UNITED STATES PATENT AND TRADEMARK OFFICE

APPLICATION NO.	FILING DATE	FIRST NAMED INVENTOR	ATTORNEY DOCKET NO.	CONFIRMATION NO.
10/719,613	11/21/2003	Jason Matthew English	KCC 4947 (K-C 18, 027)	3131
321	7590	10/04/2005	EXAMINER	
SENNIGER POWERS LEAVITT AND ROEDEL ONE METROPOLITAN SQUARE 16TH FLOOR ST LOUIS, MO 63102			BOGART, MICHAEL G	
			ART UNIT	PAPER NUMBER
			3761

Office Action Summary	Application No. 10/719,613	Applicant(s) ENGLISH ET AL.	
	Examiner Michael G. Bogart	Art Unit 3761

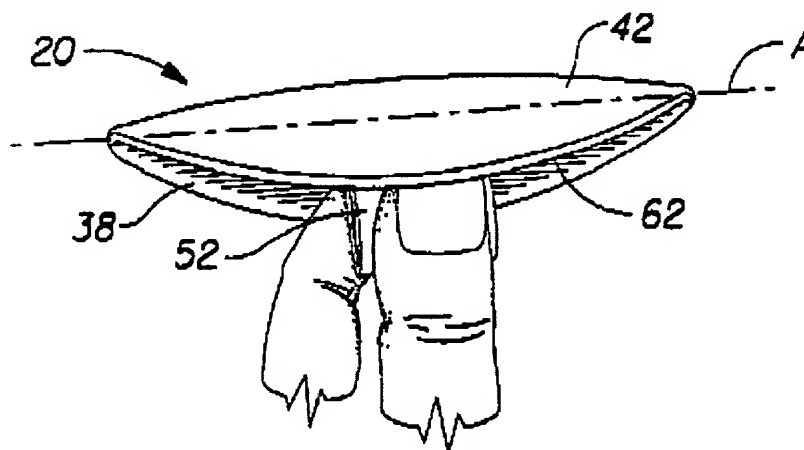
Bewick-Sonntag *et al.* disclose the claimed invention except for the specifically claimed test results and various parameters including length, density and thickness. Although the reference might inherently achieve the test results, this Office has no means for determining whether this is the case (see figure 4, below)(paragraphs 0110-0115, 0309 and 0310).

Regarding claims 17, 32 and 47, Bewick-Sonntag *et al.* teach an absorbent article (20) comprising a permeable topsheet (42) and an impermeable backsheet (38) enveloping an absorbent core (44)(figure 4).

Regarding claims 33 and 48, Bewick-Sonntag *et al.* teach an absorbent article (20) having a predetermined axis of flexure (X)(see figure 4, supra).
